Project No. 2023_079

MIDLOTHIAN ISD FRANK SEALE MIDDLE SCHOOL
INDOOR GOLF FACILITY

December 20, 2023

SHEET NO.
A-202
AGENCY NO.

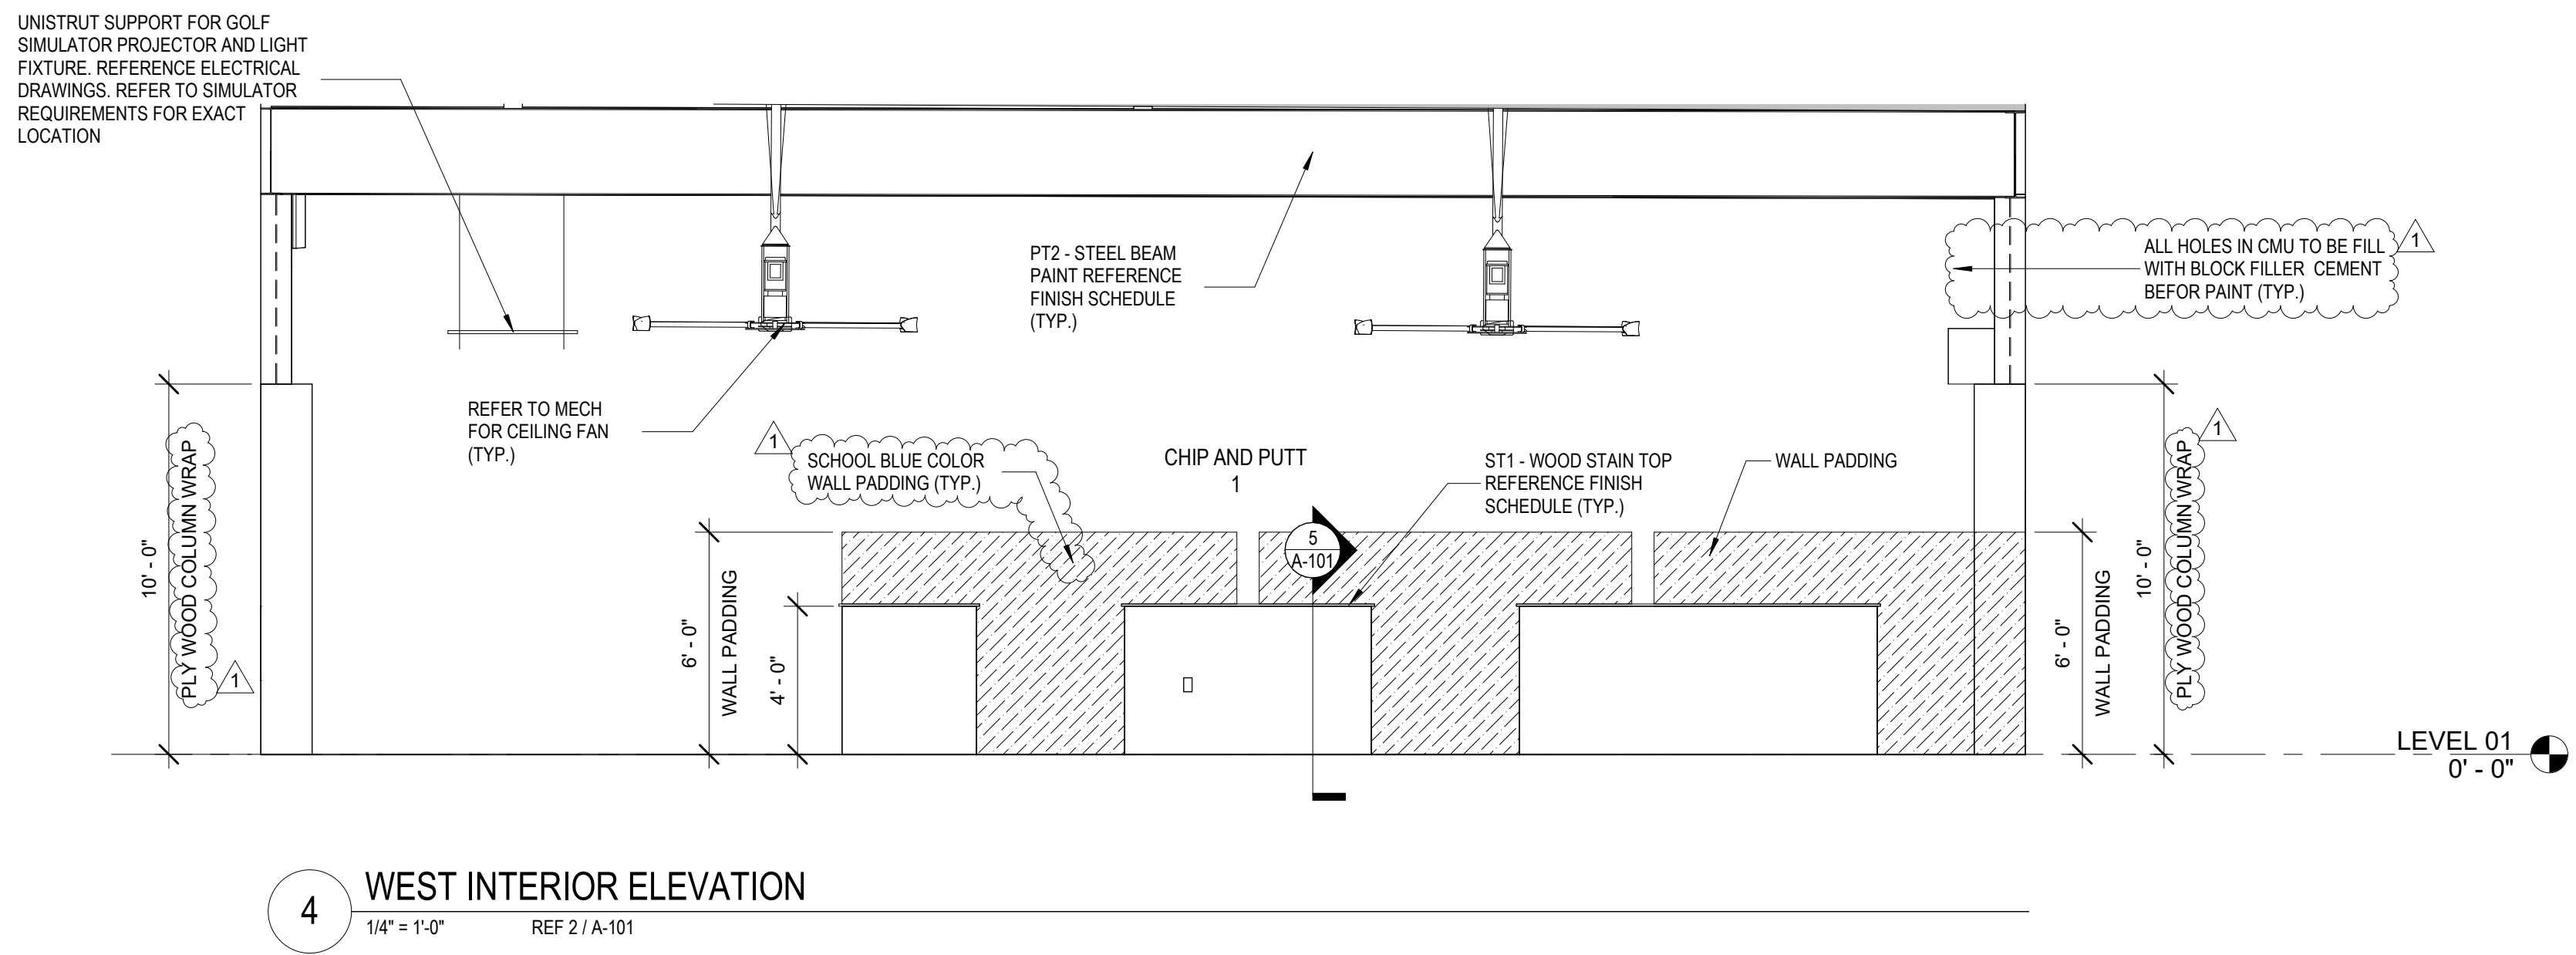
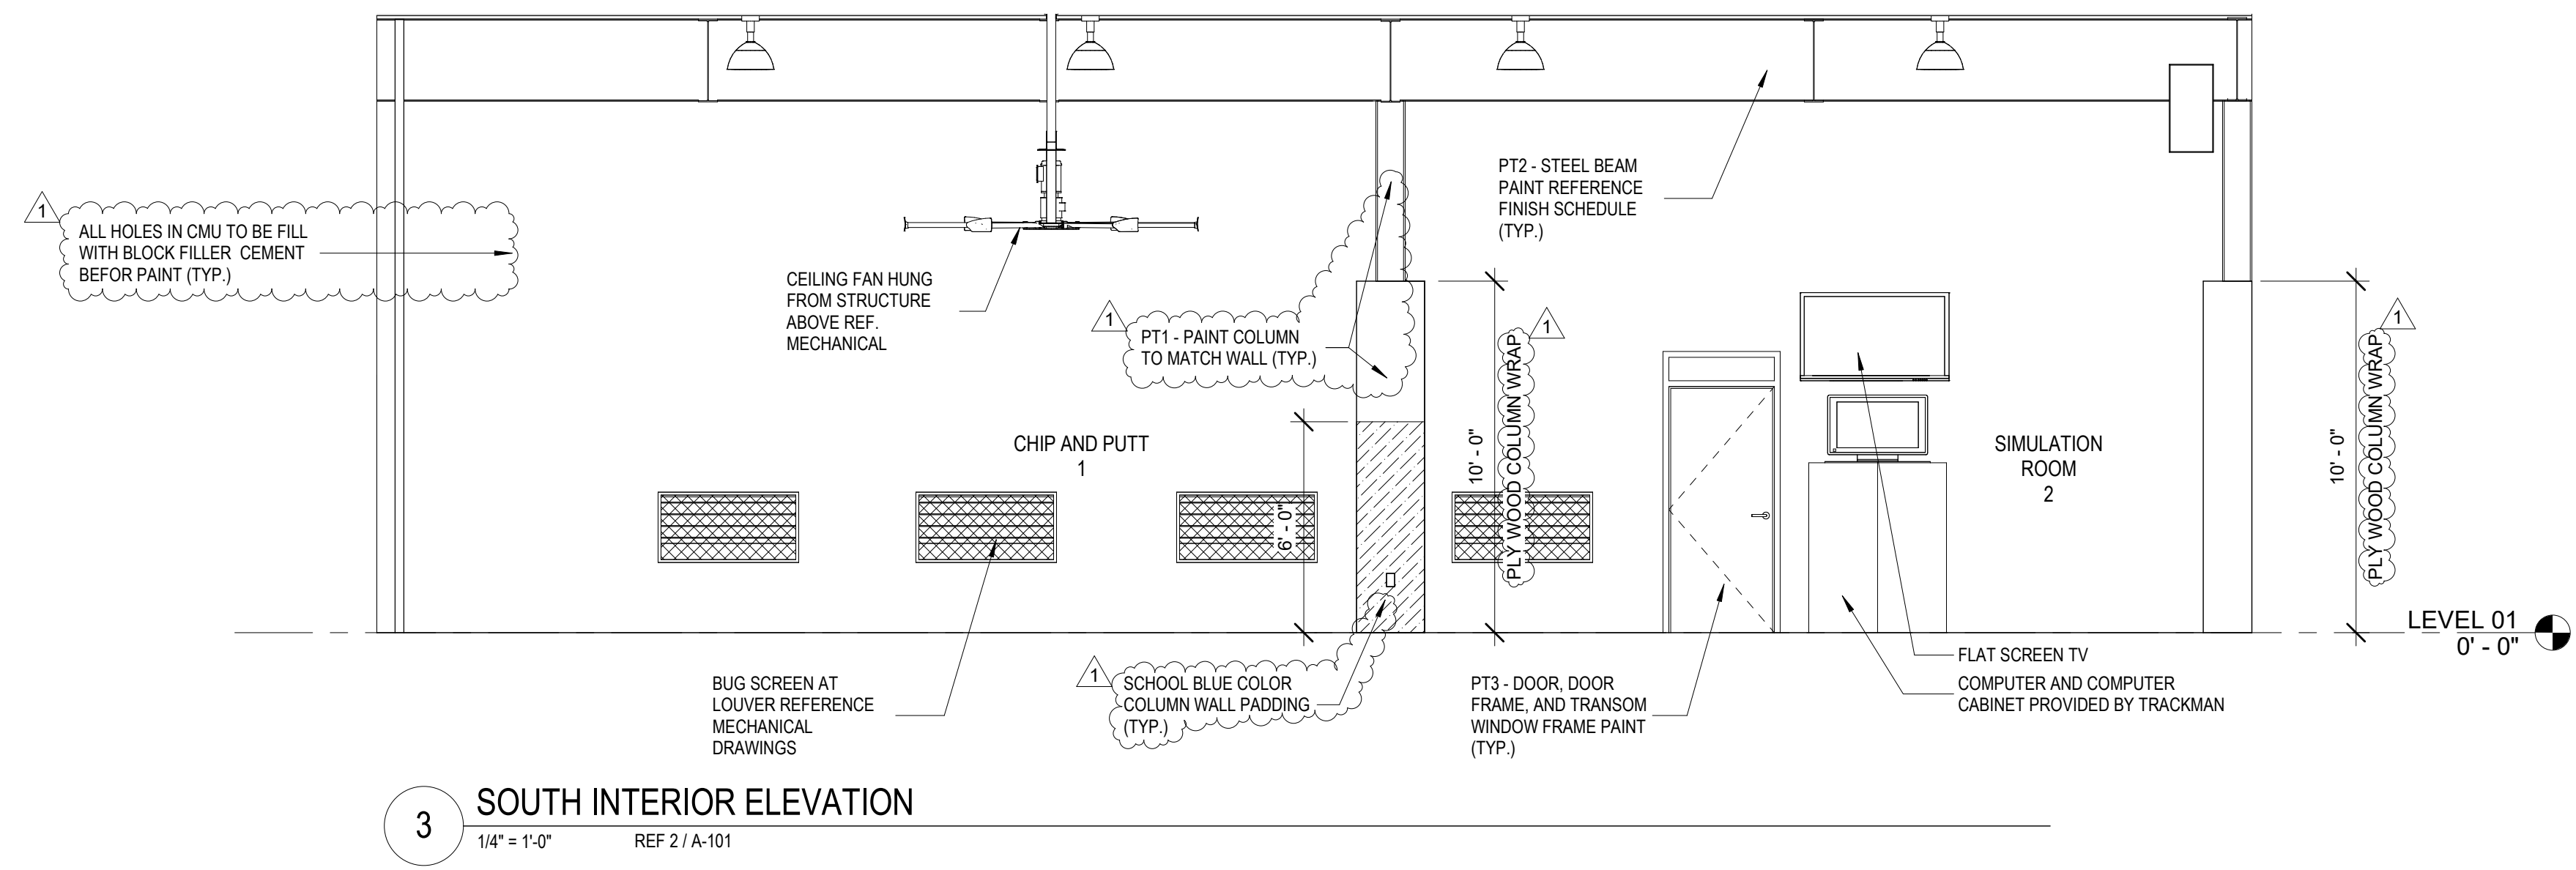
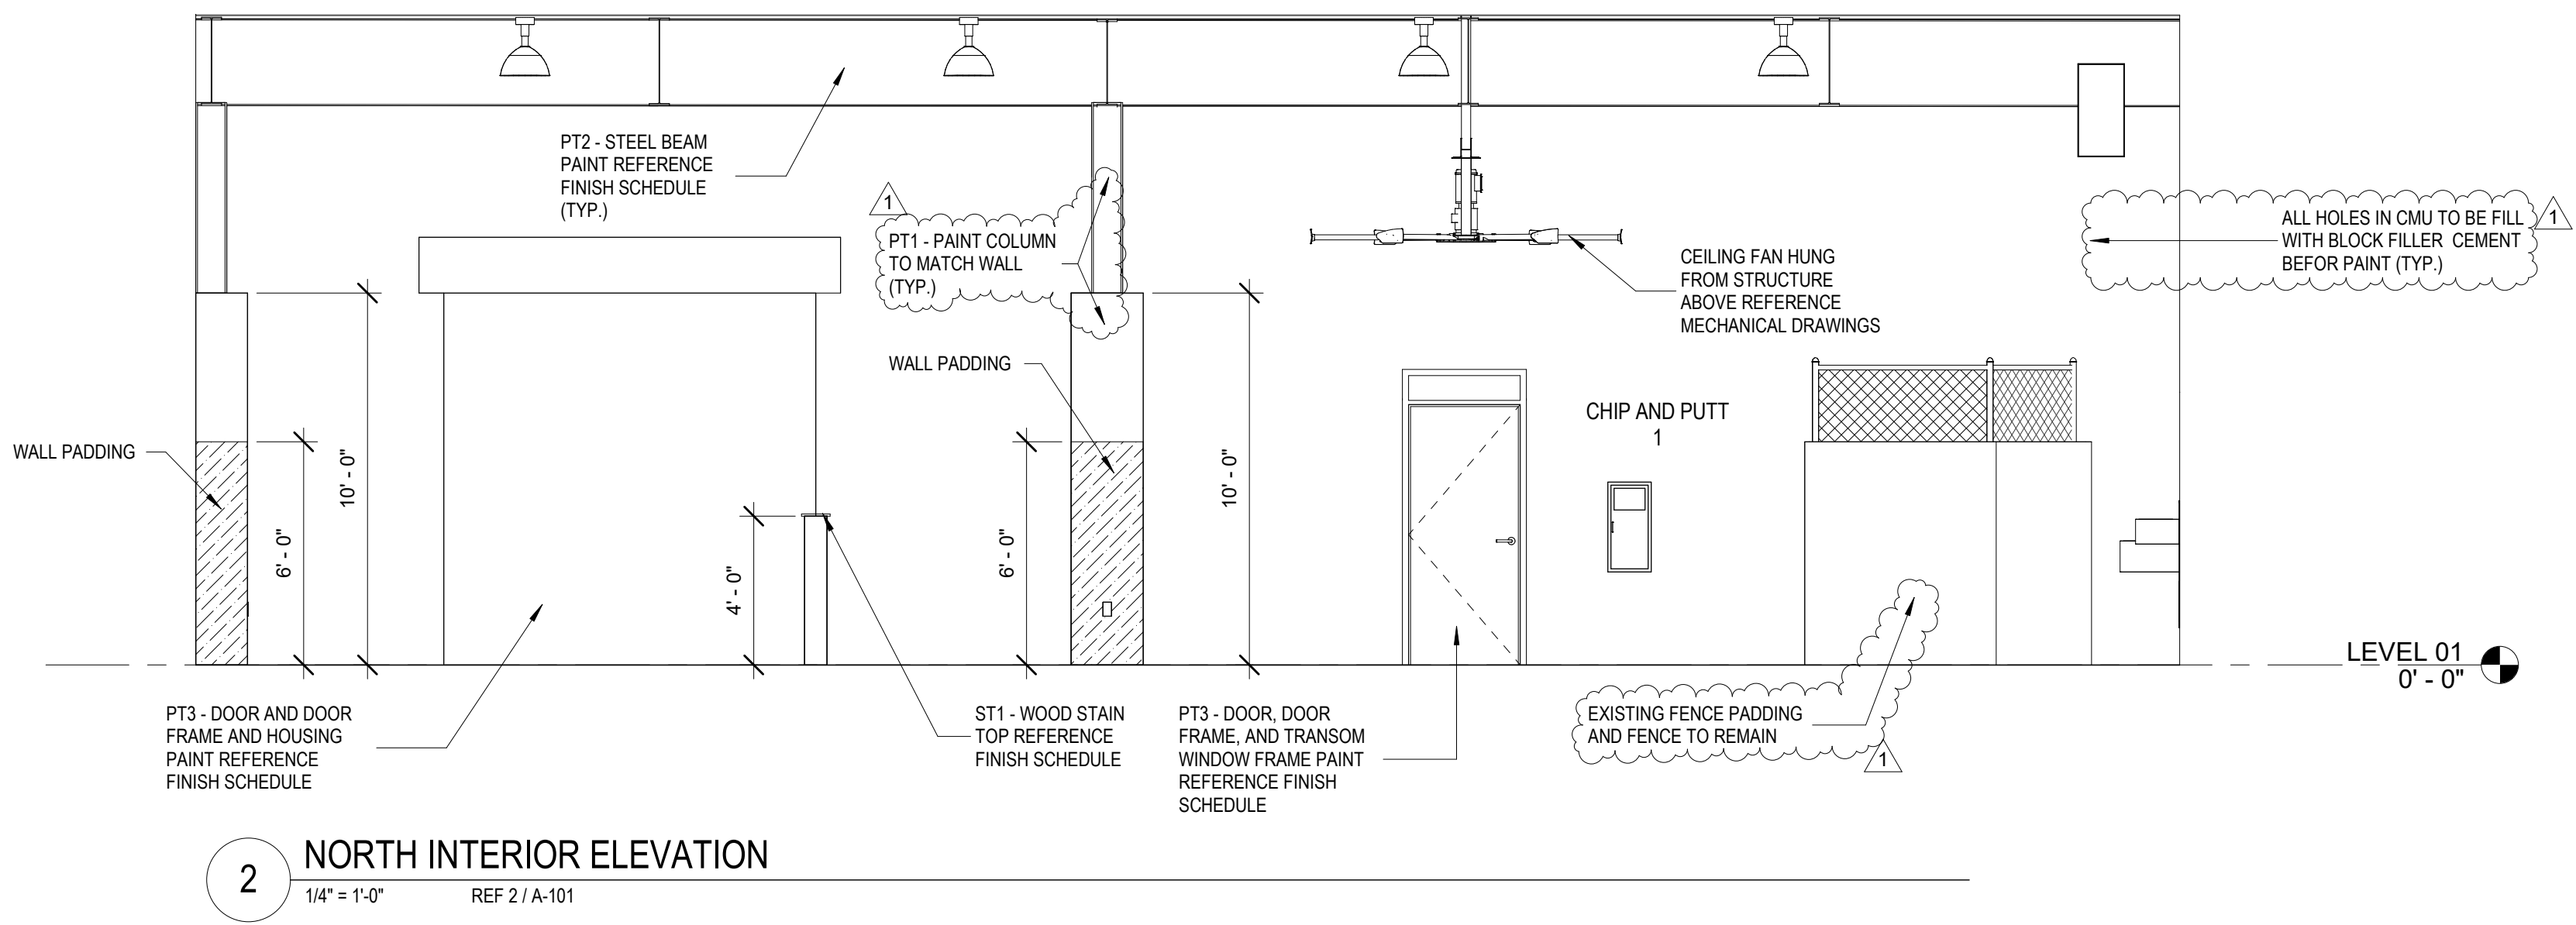
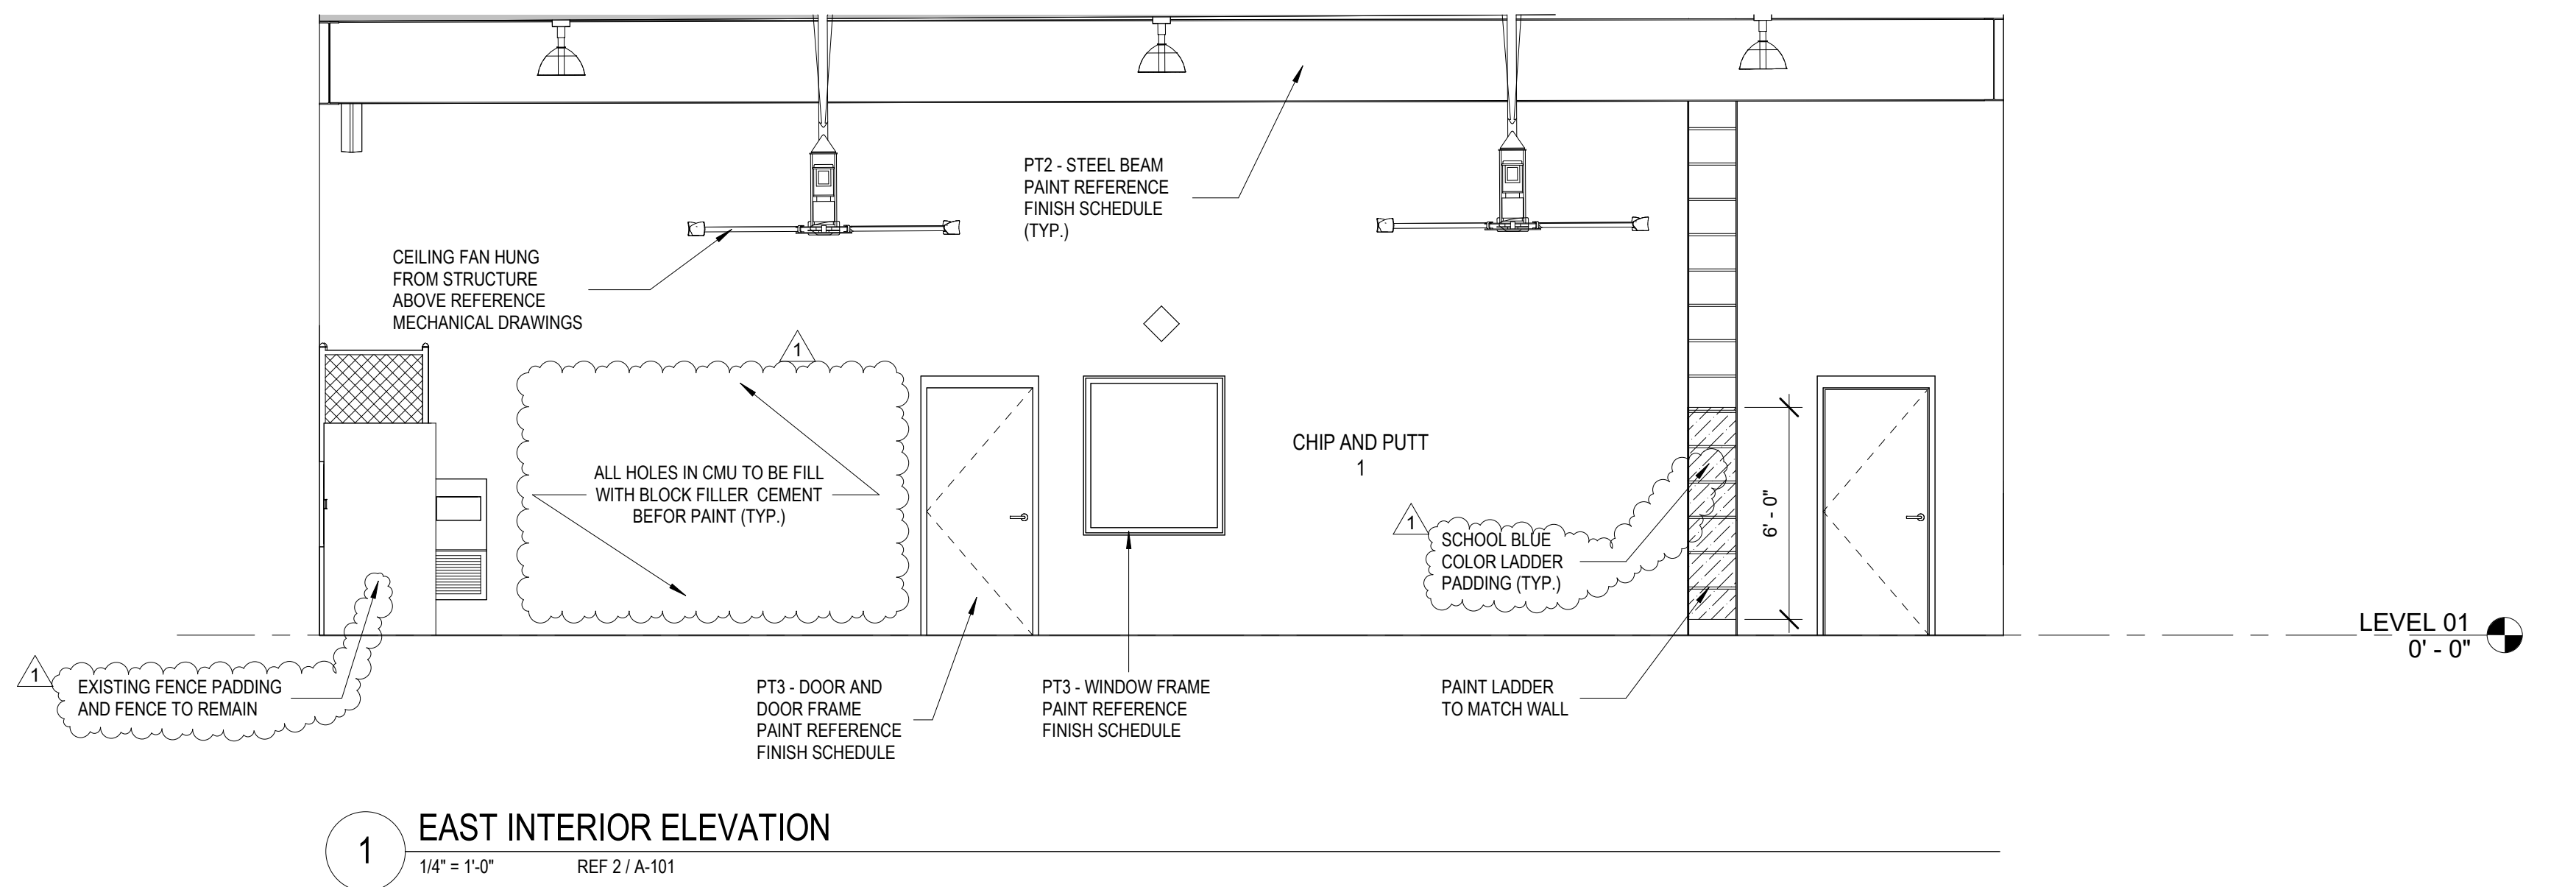
1. Added note to east interior elevation for existing fence padding and fence to remain. Also, added a note to use school color blue for ladder padding.
2. Added note to north interior elevation to paint entire column PT1 which is to match wall paint.

3. Added note to use the school color blue for column padding and to use plywood column wrap.
4. Added note to use the school color blue for wall padding.
5. Added note to CMU wall to use block filler cement on all holes and cracks.
